ZONING STAFF REPORT

Date: November 12, 2021
Case No.: 2021-2355-ZC
Posted: November 26, 2021

PETITIONER: George Kurz
OWNER: Honeybee Holdings, LLC
REQUESTED CHANGE: From A-4A Single-Family Residential District TO A-4A Single-Family Residential District and PUD Planned Unit Development
LOCATION: Parcel located on the east and west sides of Honeybee Road, north of US Highway 190; Slidell; S35, T8S, R13E; Ward 9, District 11
SIZE: 275.33 acres

CONCEPTUAL PLAN FOR REZONING HONEYBEE SUBDIVISION A PLANNED UNIT DEVELOPMENT SECTION 35, TOWNSHIP 8 SOUTH - RANGE 13 EAST GREENSBURG LAND DISTRICT ST. TAMMANY PARISH, LOUISIANA

Not For Construction
P.U.D. WALKING
EXHIBIT

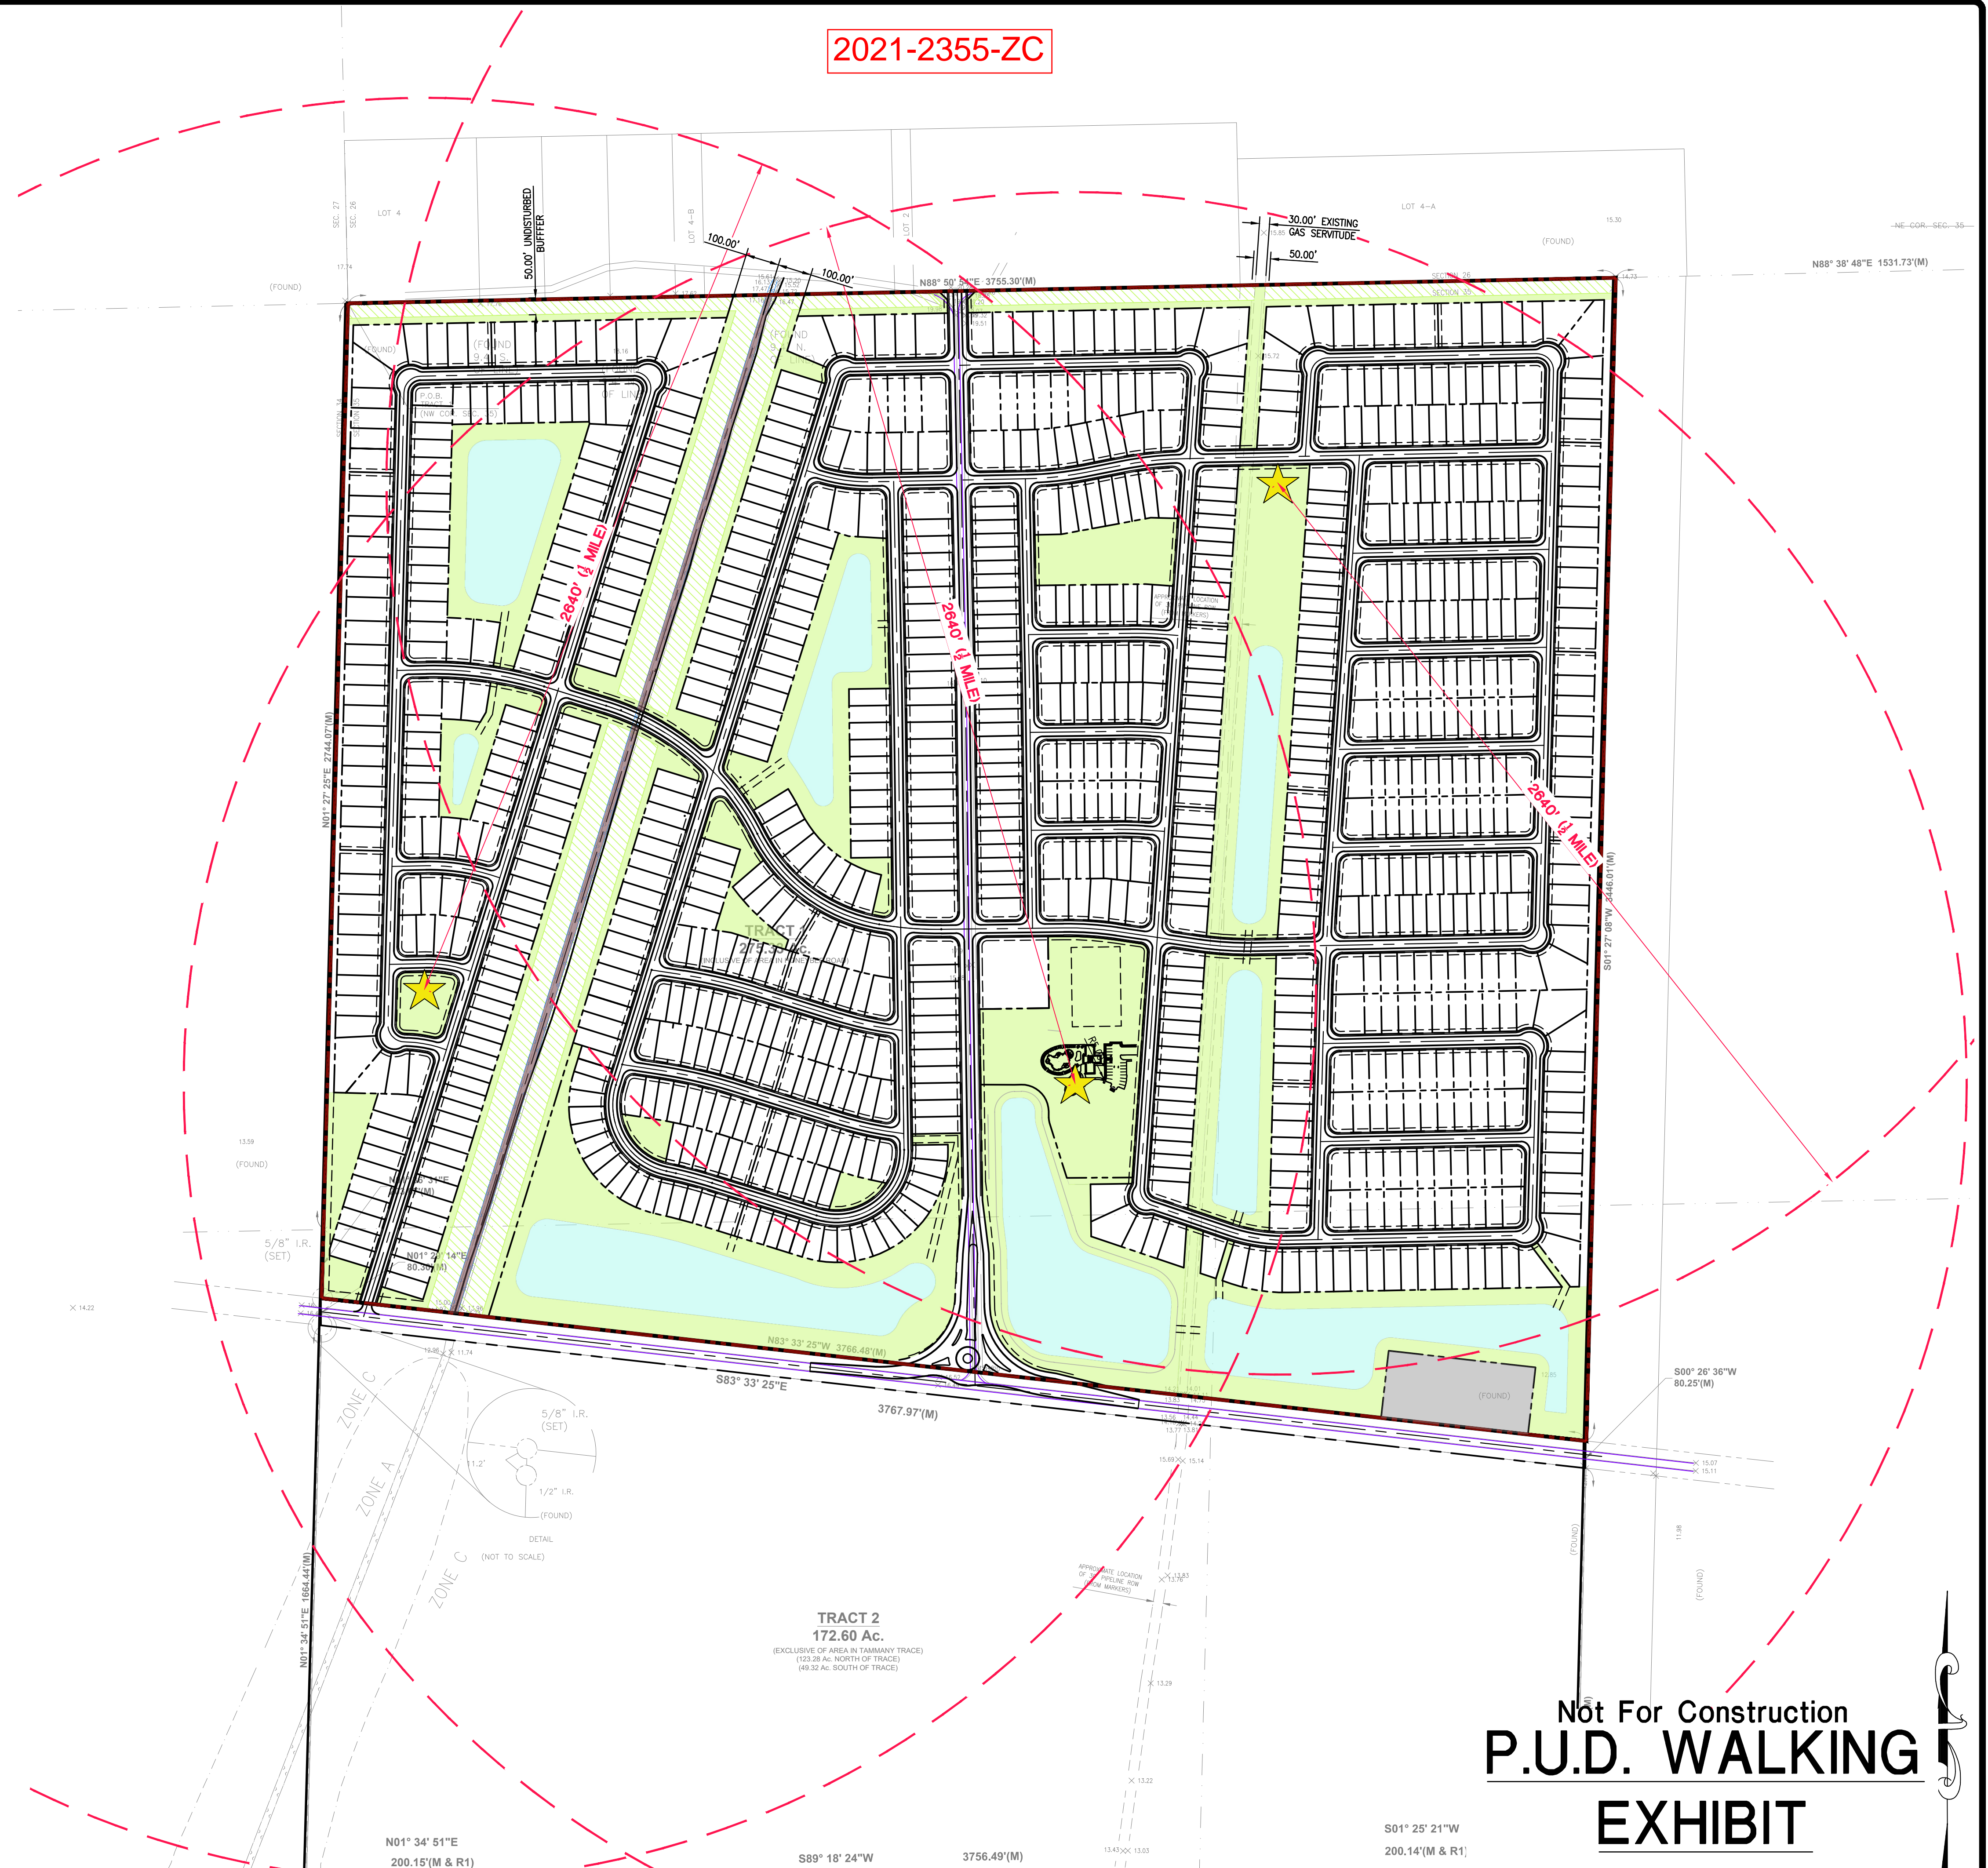
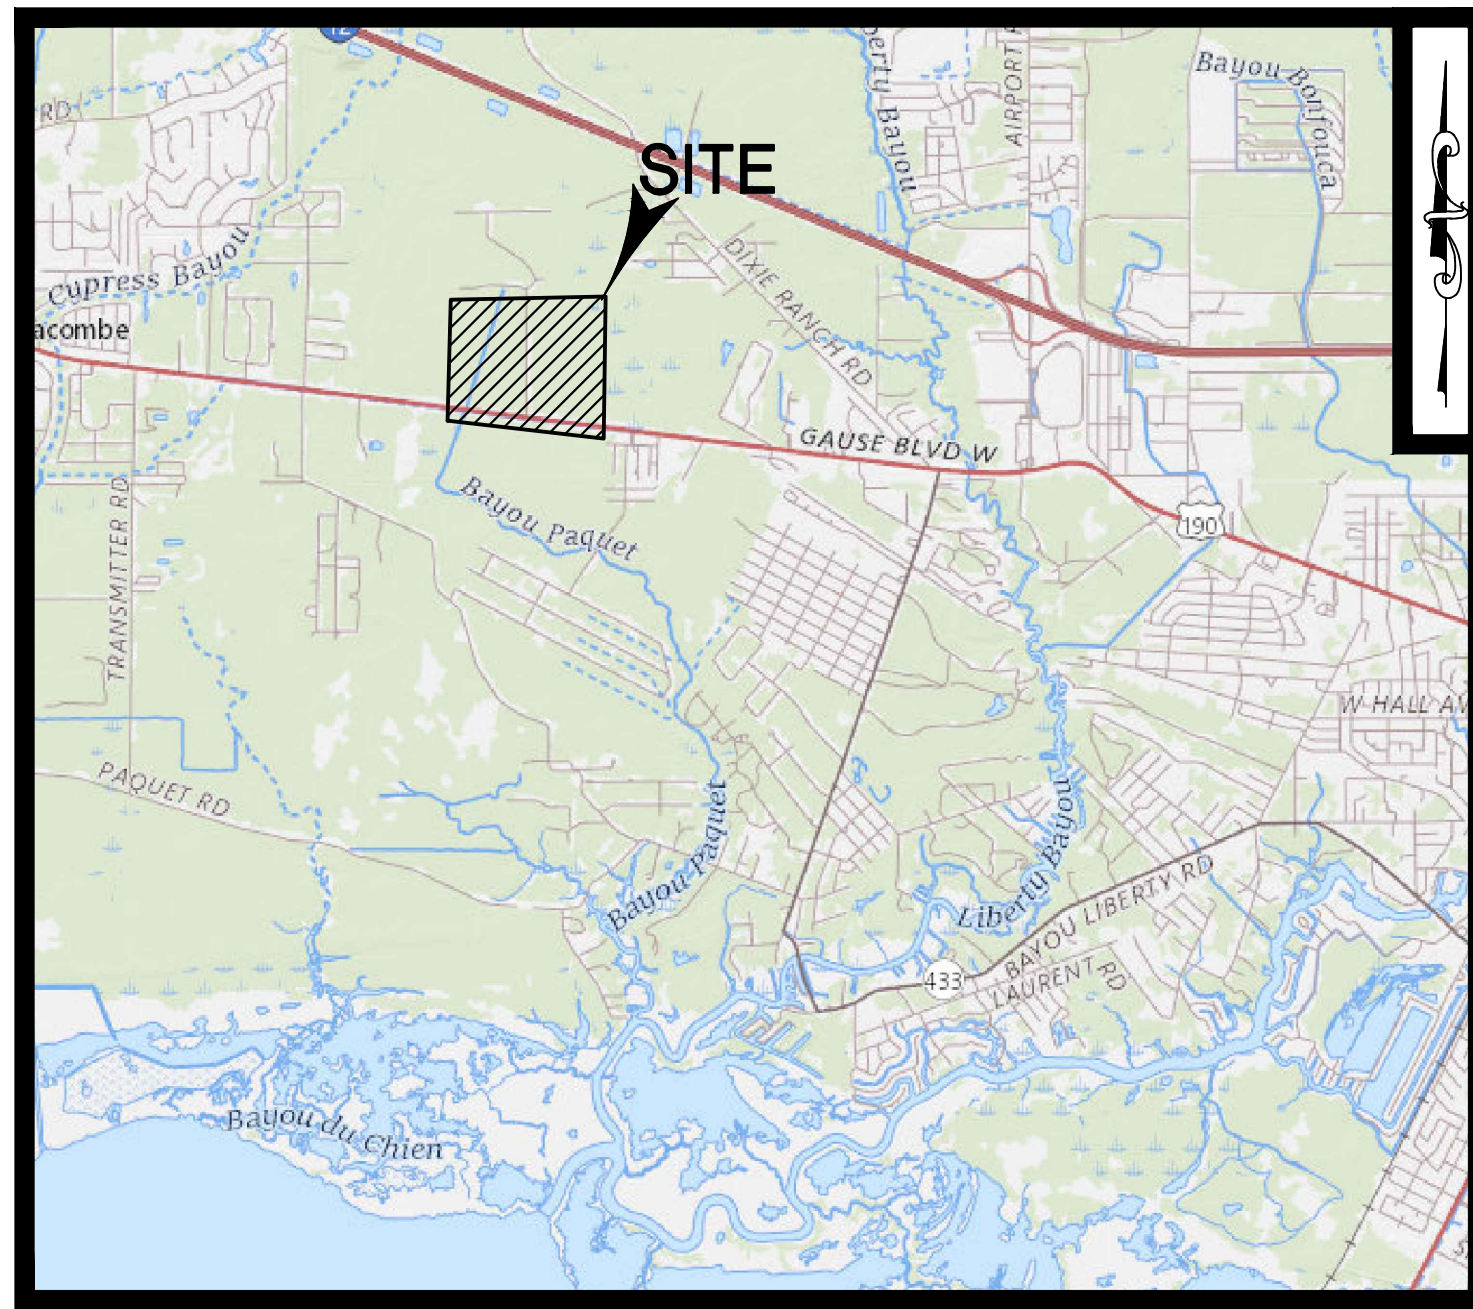
Staff has concerns that a large majority of the greenspace provided is comprised of easements, servitudes, and buffers, and therefore ~~does not meet the intent of the PUD requirements~~ **is not of a higher quality than would be possible without the PUD.** (see Table 4). ~~While not opposed to the addition of several acres of pocket parks situated throughout the PUD, staff would like to see that more amenities are added to these parks to ensure the greenspace that is provided is functional and beneficial to the residents. Currently, it appears as though the Honeybee PUD is providing three playground sets and an “open field” to accommodate 962 proposed home sites.~~ **As per Table 4, if the applicant eliminated Bayou Paquet, the gas servitude, “space around the lakes”, and buffers from the total amount of greenspace provided, the PUD plan would be providing 36.59 acres, which is merely 53% of the greenspace required.**

- ~~Due to the proposed high density of this PUD, the applicant should ensure every home site has access to a substantial greenspace amenity. In addition, the applicant should ensure parking is provided at all three amenity sites to ensure that every home has reasonable access.~~
- **The applicant has provided a “PUD Walking Exhibit” which shows a ½ mile radius circle centered on each park location. This plan illustrates that every lot in the development is within ½ mile from a playground. In addition, the developer has agreed to add parking at all playground locations to ensure that every home has reasonable access.**
